Subject: East Altamont Energy Center Application for Certification
Data Request Response Set #1 (01-AFC-04)

East Altamont Energy Center
Data Requests and Responses (01-AFC-4)
Set #1

EAST ALTAMONT ENERGY CENTER DATA REQUEST AND RESPONSE SET #1 (01-AFC-4)

Technical Area: Visual Resources

Figure 6.1a

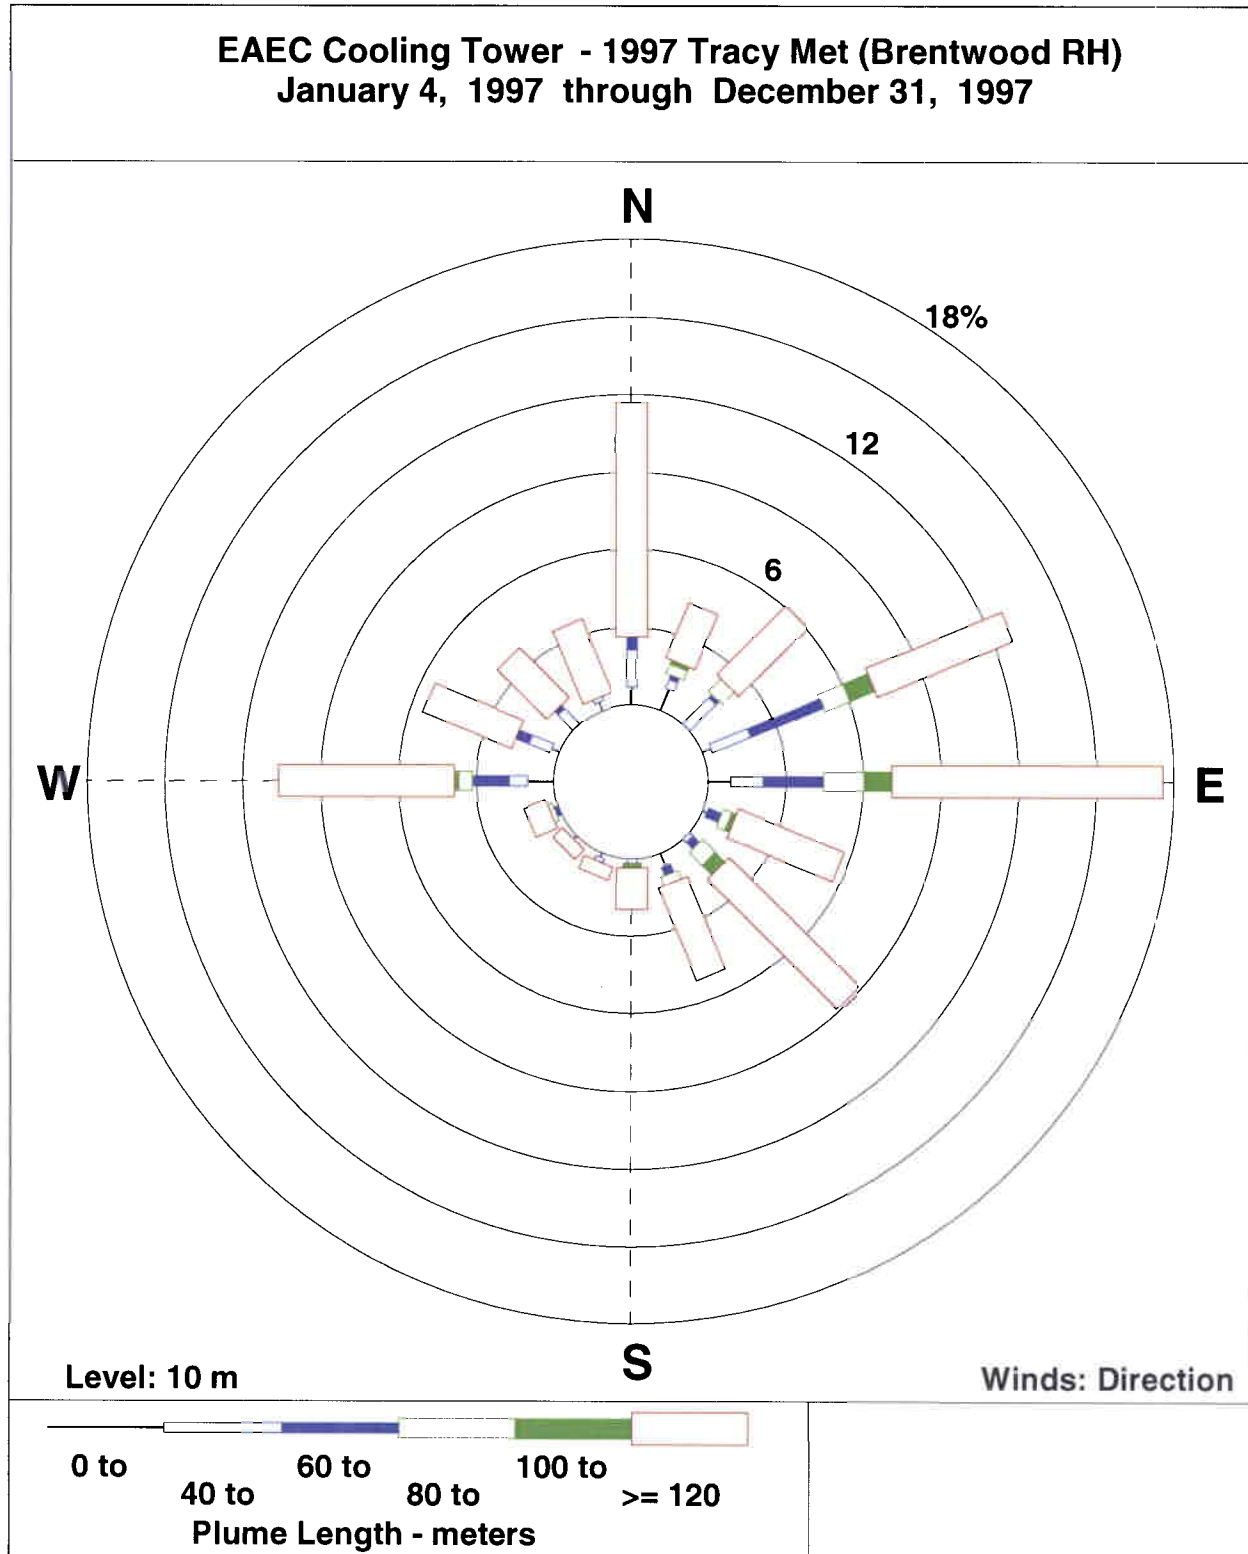
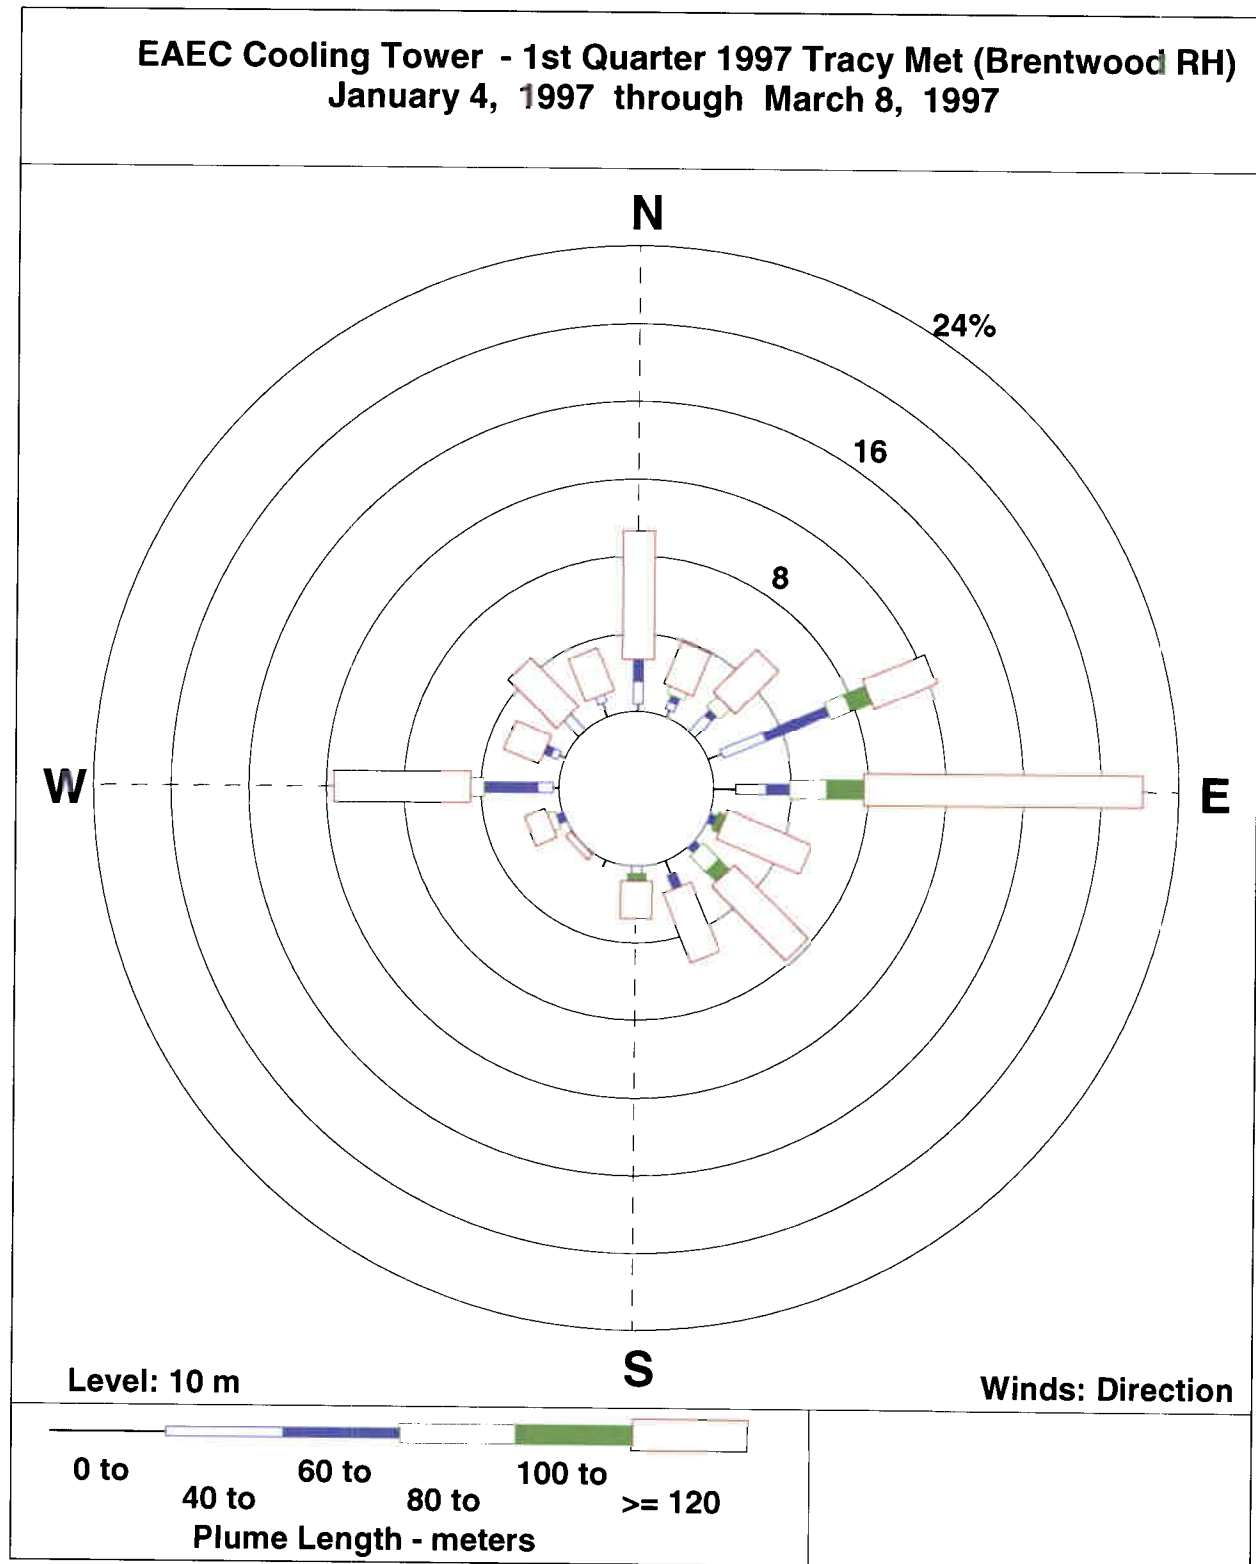
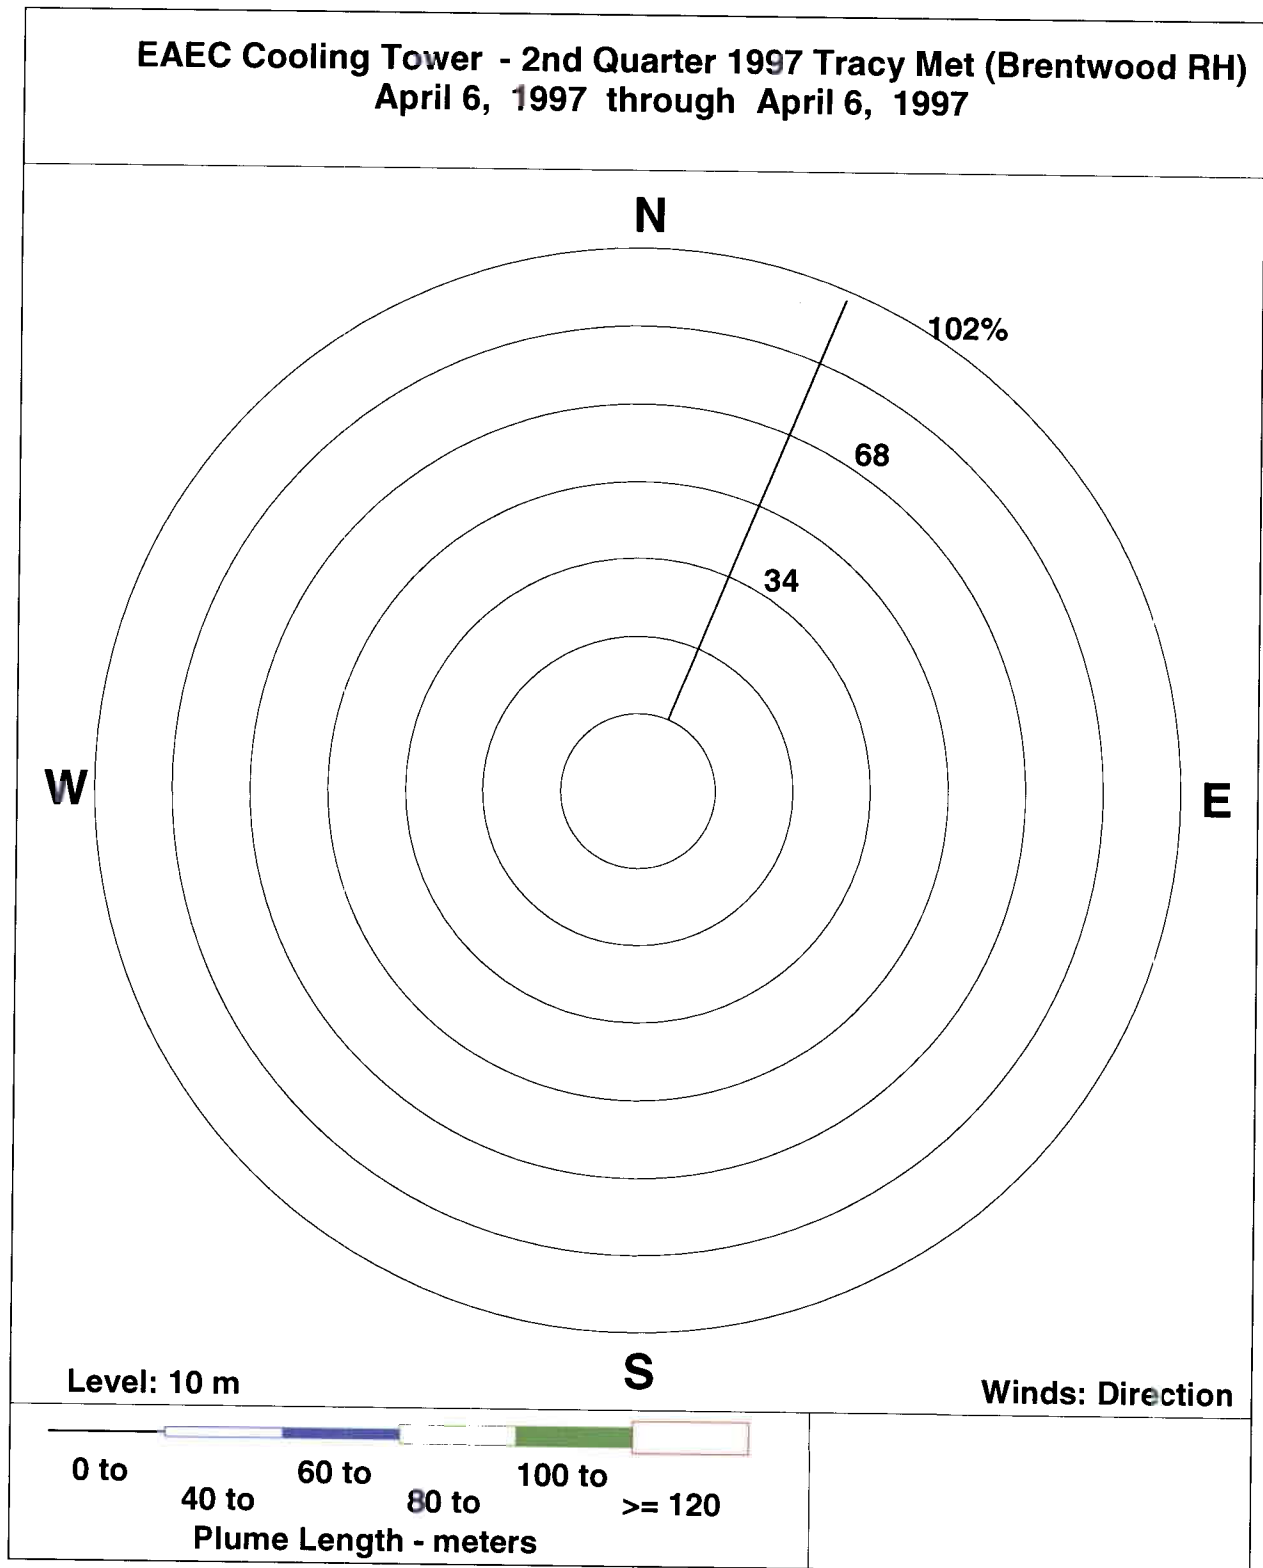
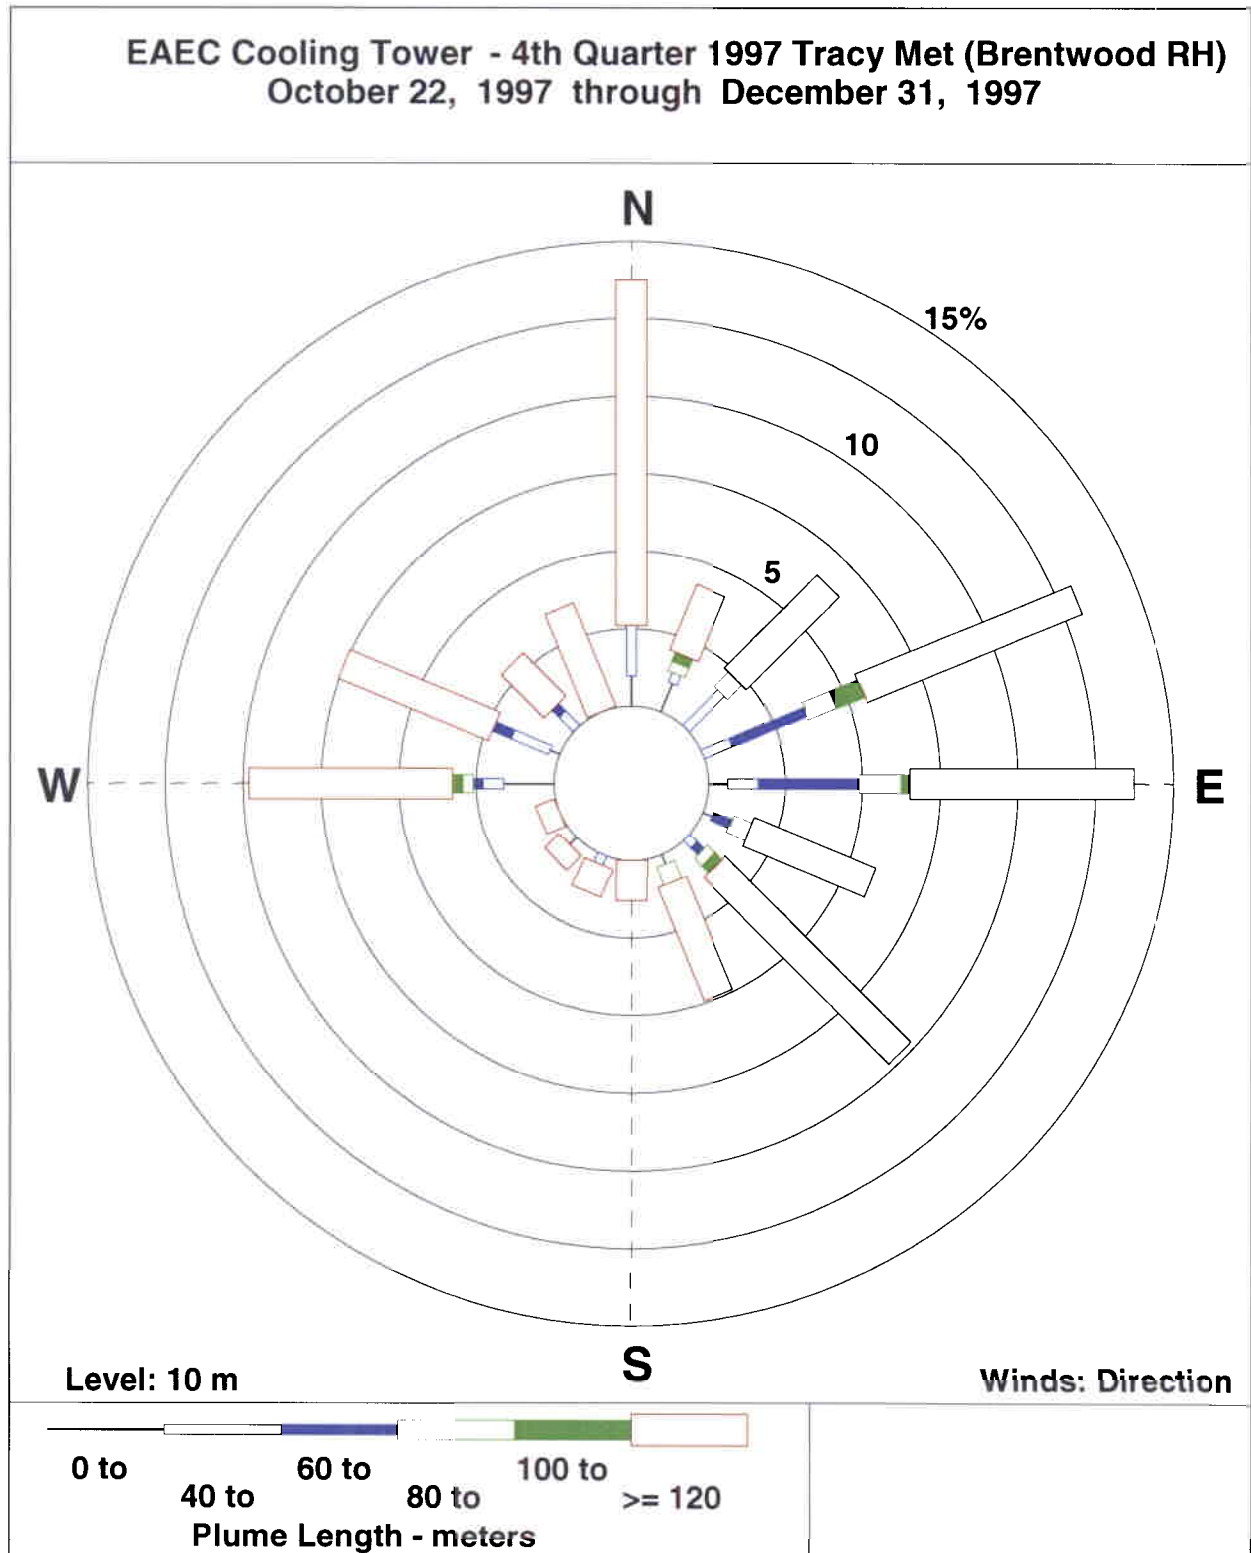
- a. The total number of daylight hours annually and seasonally;

Response: Table VIS-6.1 shows the number of hours per year that there is the potential for formation of a visible water vapor plume of various lengths from each cooling tower cell. The analysis assumes that each cooling tower cell is operated for 8,760 hours per year. The analysis was performed for each of the three years of meteorological data available.

A seasonal distribution of these hours is presented in the plume roses included as Figures VIS-6.1a through VIS-6.1l.
